ARCHITECT'S SUPPLEMENTAL INSTRUCTIONS

Date Issued:	August 13, 2021
Project:	Northpointe Medical Park- Labcorp- TI Building-'C'- Level 2 2326 North 400 East Tooele, UT, 84074
Architect's Supplemental Instructions:	ASI #1
To:	Saunders Construction 1113 South 500 West Bountiful, Utah 84010

Subject: Plan Review Response "**Northpointe Medical- Labcorp T.I.**" located at "Building 'C'- Level 2, 2326 North 400 East- Tooele UT 84074". Tooele City #: P21-421 (WC3 Project # 221-524-010)

Code Review Comments:

1 Door Types NOTE: REFER TO "DOOR SCHEDULE" TABLE FOR DOOR TYPES REQUIRED FOR THIS PROJECT. SOME DOOR TYPE ELEVATIONS INDICATED ABOVE, MAY NOT BE APPLICABLE TO THIS PROJECT.
SCALE: 1/4" = 1'-0"

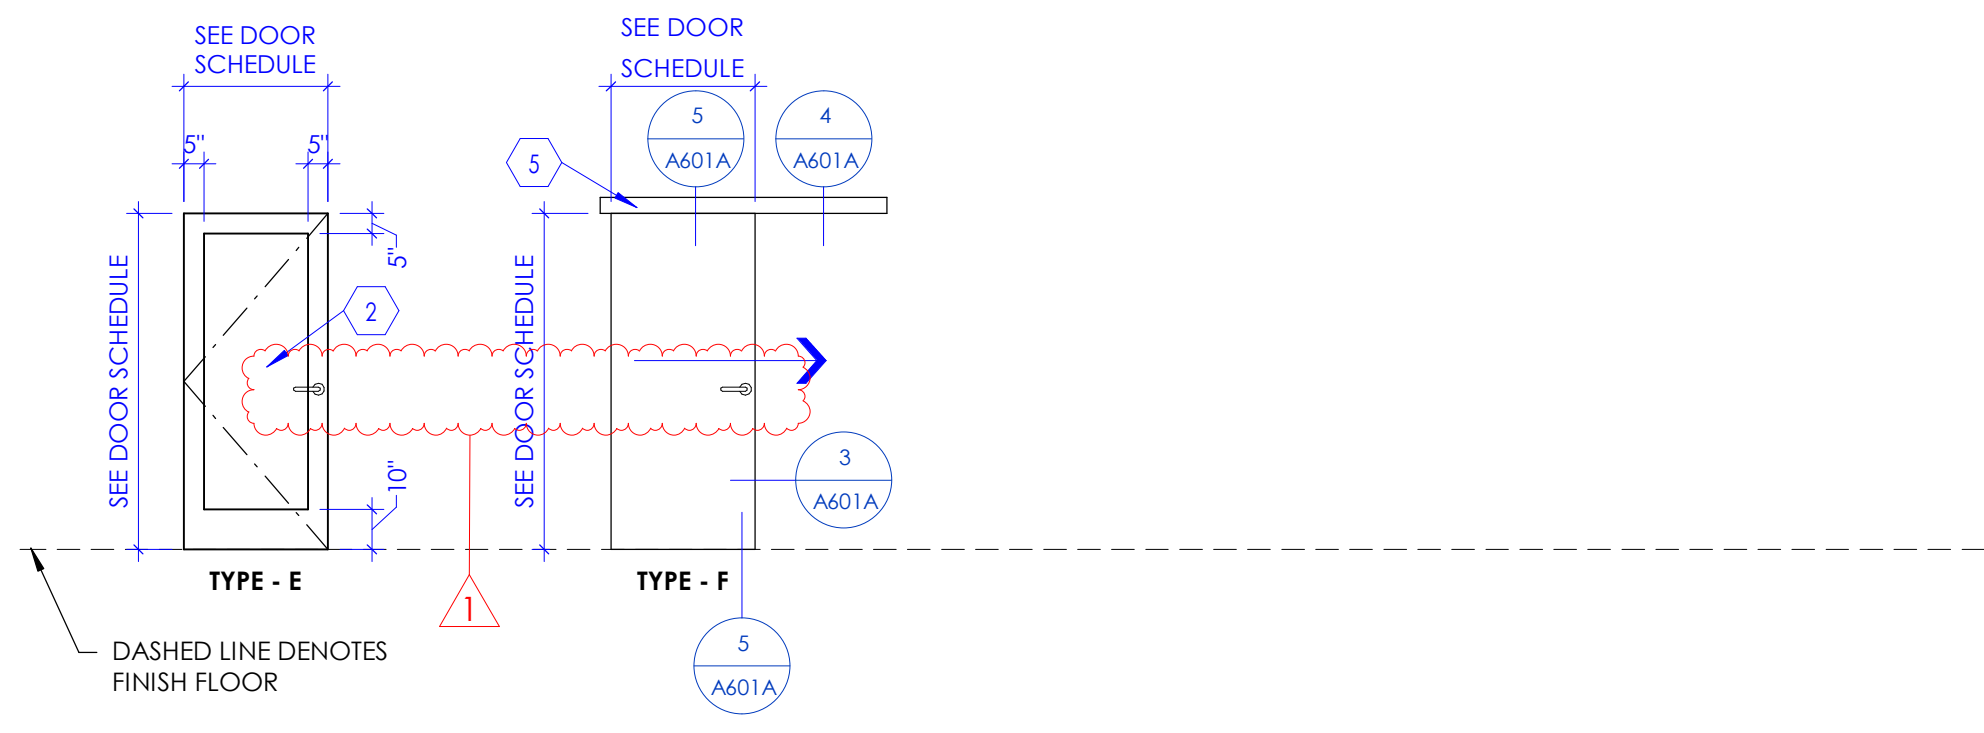
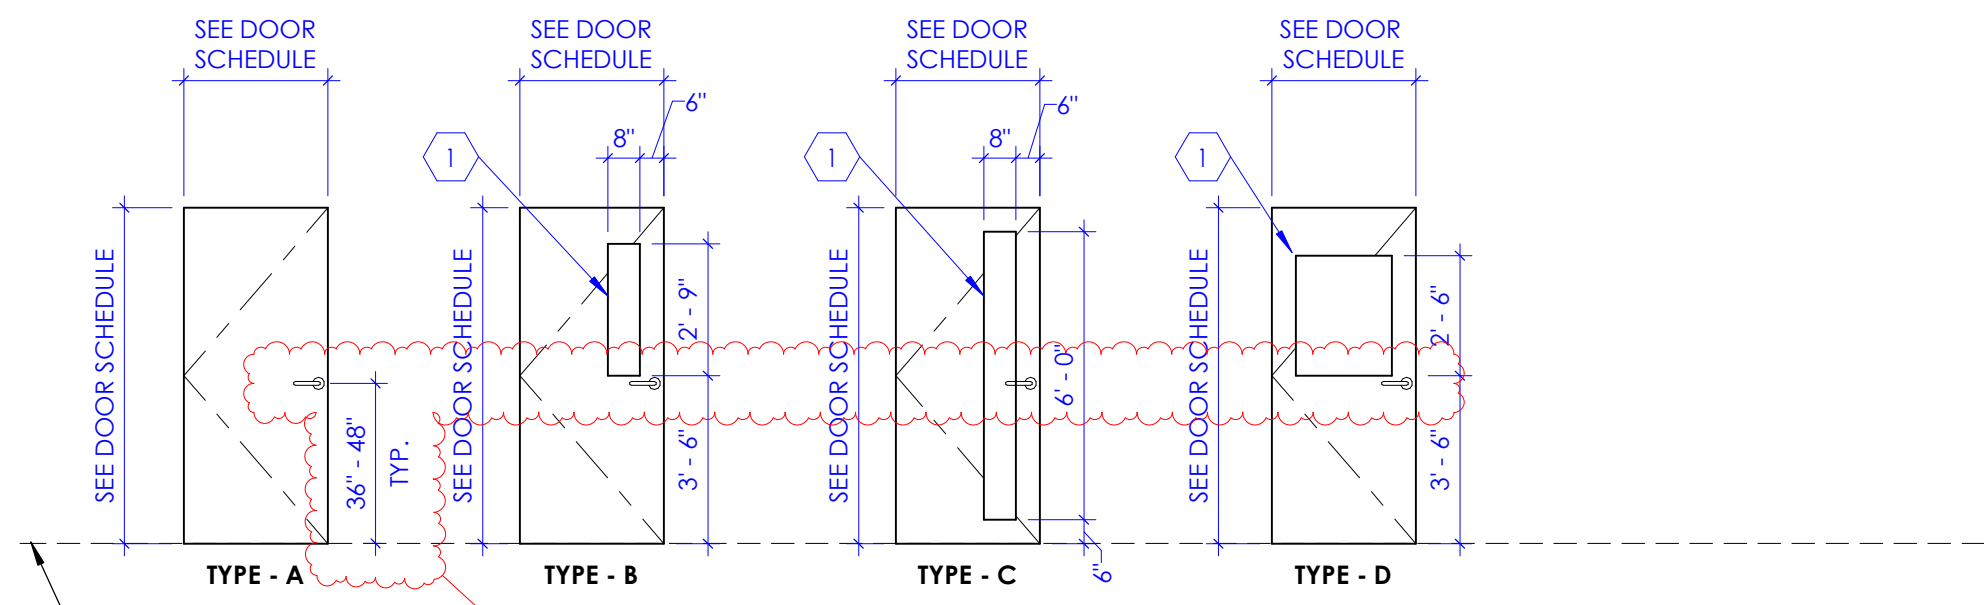
B. Include in the door elevation details the mounting heights for the door hardware in accordance with IBC 1010.1.9.2. All locks, door handles, pulls, latches, or other operating hardware is required to be located between 36 and 48 inches above finished floor.

Response: Required note and elevation has been added on sheet A601A. See revised sheet A601A for more information.
